From: Technical Support technical@thermoguard.co.uk
Subject: Re: MJM - Fire Doors
Date: 19 November 2020 at 15:10
To: Candice Moore candice@citizensdesignbureau.net

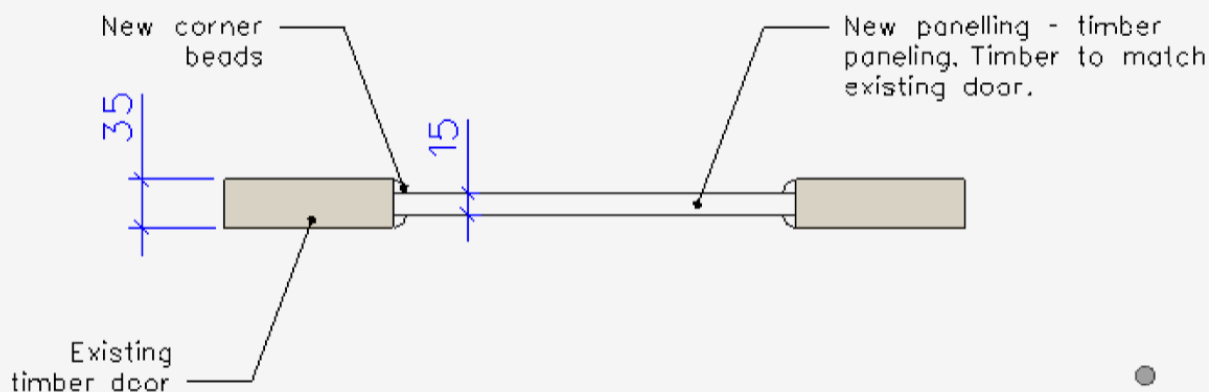
On Thu, 19 Nov 2020 at 15:09, Candice Moore <candice@citizensdesignbureau.net> wrote:
Thanks, would upgrading it as below be acceptable:

Just checking our doors of 45mm with 13mm panels okay?

Hi Candice,
If approved by your building inspector then yes.
